MCMA,MCMI,MCMB,MCMJ

Accessories Change Notification

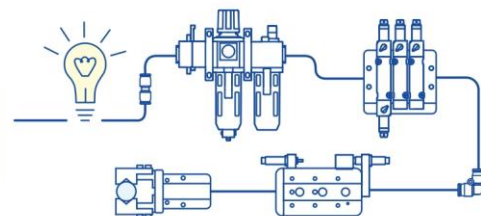
MCMA,MCMI-Y/I connector			
Tolerance for ØX hole:		Tolerance for ØX hole:	
Code Tube I.D.	ØX ^{H9}	Code Tube I.D.	ØX
8,10	4 ^{+0.03} ₊₀	8,10	4 ^{+0.1} _{+0.01}
12,16	6 ^{+0.03} ₊₀	12,16	6 ^{+0.1} _{+0.01}
20	8 ^{+0.036} ₊₀	20	8 ^{+0.1} _{+0.01}
25,32	10 ^{+0.036} ₊₀	25,32	10 ^{+0.1} _{+0.01}
40	12 ^{+0.043} ₊₀	40	12 ^{+0.1} _{+0.01}

MCMJ Normally returned ` Normally extended

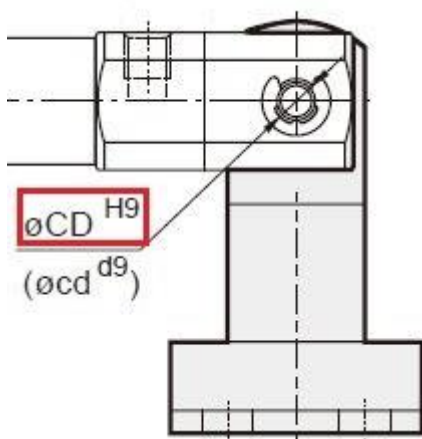
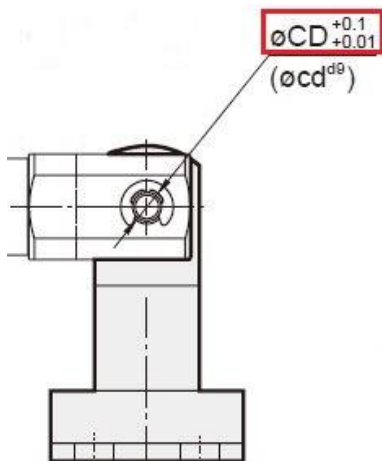
Tolerance for ØCD hole:	Tolerance for ØCD hole:
